DEVELOPMENT ASSESSMENT REPORT				
Application No.	DA201900034			
Address	96 - 98 May Street, St Peters			
Proposal	To demolish existing improvements and construct a four (4)			
	storey boarding house with basement parking.			
Date of Lodgement	7 February 2019			
Applicant	Martin Bednarczyk			
Owner	Bk Property Group Pty Ltd			
Number of Submissions	23			
Value of works	\$1,895,000			
Reason for determination at	Number of submissions			
Planning Panel				
Main Issues	Accessible car spaces			
	Communal open space hours of use			
Recommendation	Approval			
Attachment A	Recommended conditions of consent			
Attachment B	Plans of proposed development			
Attachment C	Plan of management			
110 1	May Street  90 86 82 92 90 96 19 19

## 1. Executive Summary

This report is an assessment of the application submitted to Council to demolish existing improvements and construct a four (4) storey boarding house with basement parking at 96-98 May Street, St Peters.

Figure 1: Proposed front and rear elevations of previous development application (DA201700583).

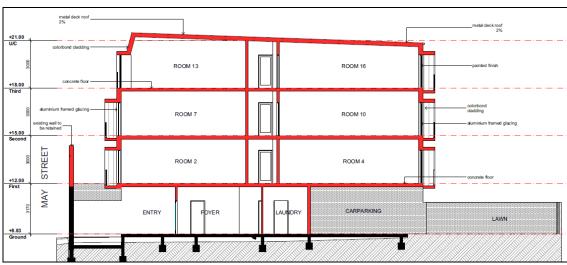
It is noted that the subject proposal was designed to address the issues raised during the appeal.
